**CITY OF SACRAMENTO
DEPARTMENT OF PLANNING & DEVELOPMENT
ZONING ADMINISTRATOR
1231 I Street, Sacramento, CA 95814**

ACTION OF THE ZONING ADMINISTRATOR

On Wednesday, April 14, 1999, the Zoning Administrator approved with conditions a plan review to construct a commercial building for the project known as Z99-015. Findings of Fact and conditions of approval for the project are listed on pages 4-6.

Request: **Zoning Administrator Plan Review** to construct a 7,000 square foot commercial building on 0.846 ± partially developed acres in the General Commercial-Review (C-2-R) zone.

NO. IN BOOK
EXTERIOR
ELEVATIONS

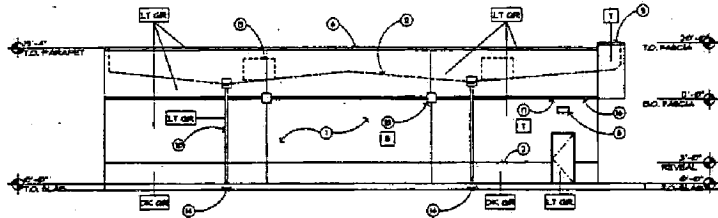
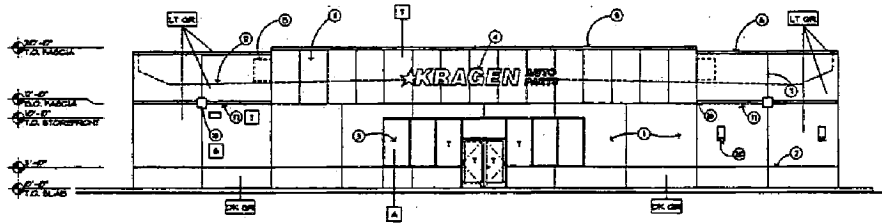
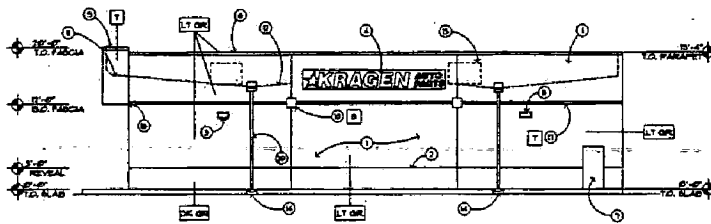
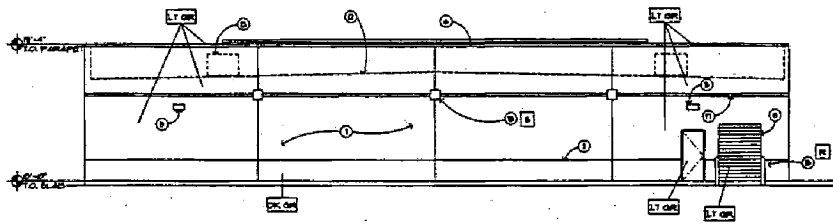
The elevations indicate that a satellite dish will be located on the roof. The dish will be exempt from planning entitlements if the dish receives only, but does not transmit. According to the Zoning Ordinance, if the satellite dish transmits and receives then a Zoning Administrator Special Permit will be required to locate the satellite dish on the roof.

18. All mechanical equipment shall be completely screened. The satellite dish on the roof shall be a receive only dish.
19. Size and location of the building shall conform to the plans submitted.
